IN THE DRAWINGS

Please amend the drawings as follows:

**FIG. 2**

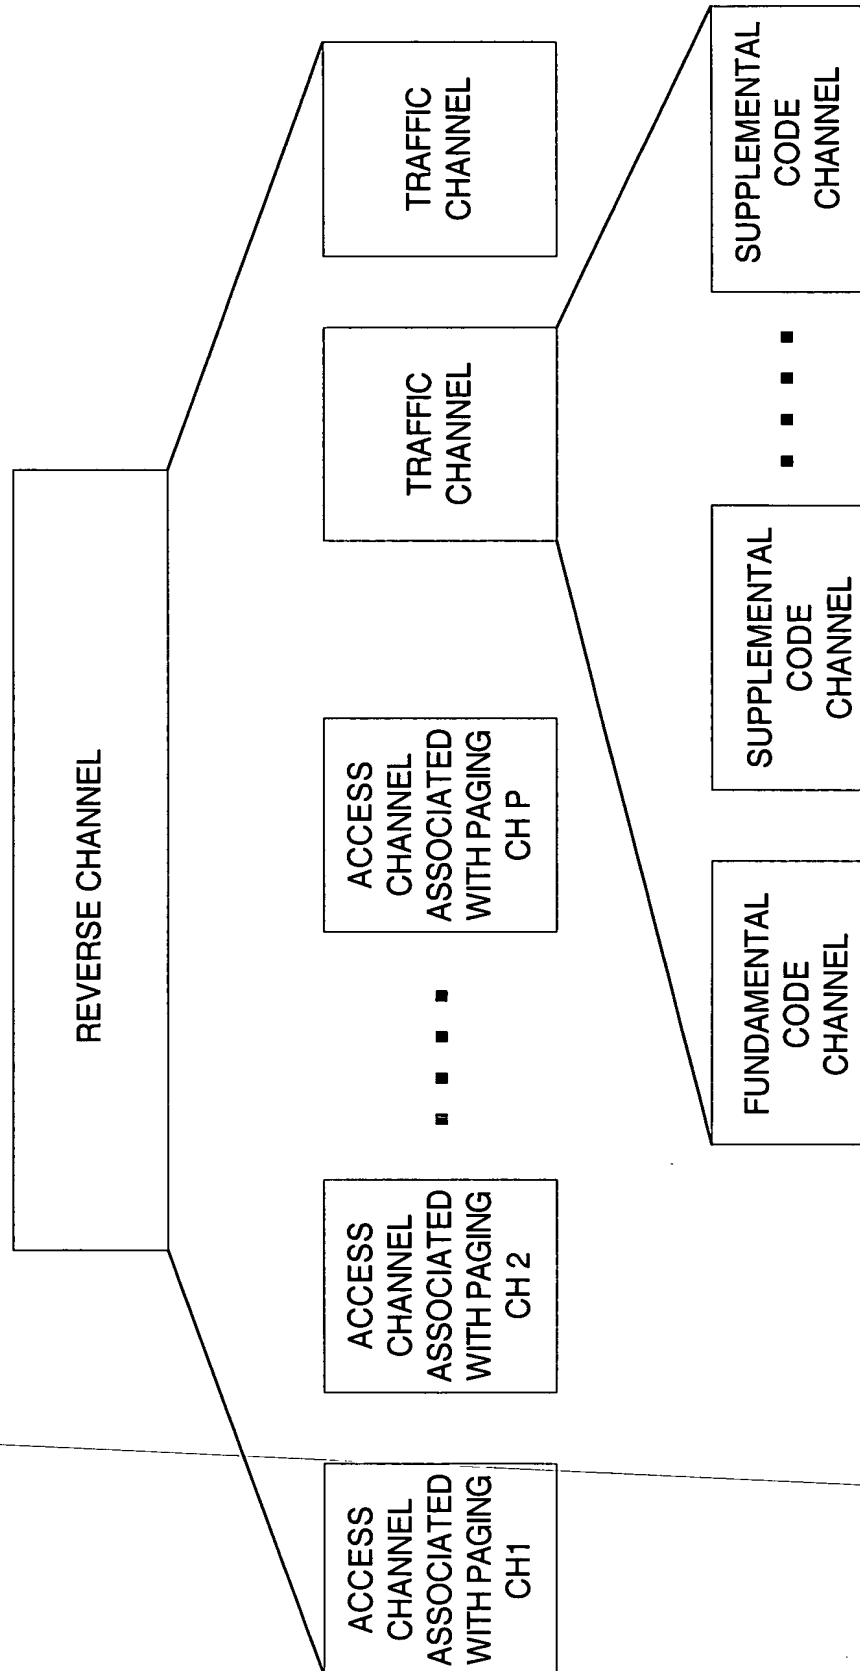
- FIG. 2        Amend “f-sch” in element “50” to read “F-CSCH.” Applicant refers to page 6 line 27.
- FIG. 4        Amend the interval from time t3 to t6 and the interval from time t6 to t9 to each be labeled “FRAME,” as shown in the attached amended drawing. Applicant refers to page 8, line 10 of Applicant’s specification.
- FIG. 8        Amend “TRANSMIT CIRCUITRY 216” as shown as in the attached amended drawing. Applicant refers to page 14, line 7 of Applicant’s specification.
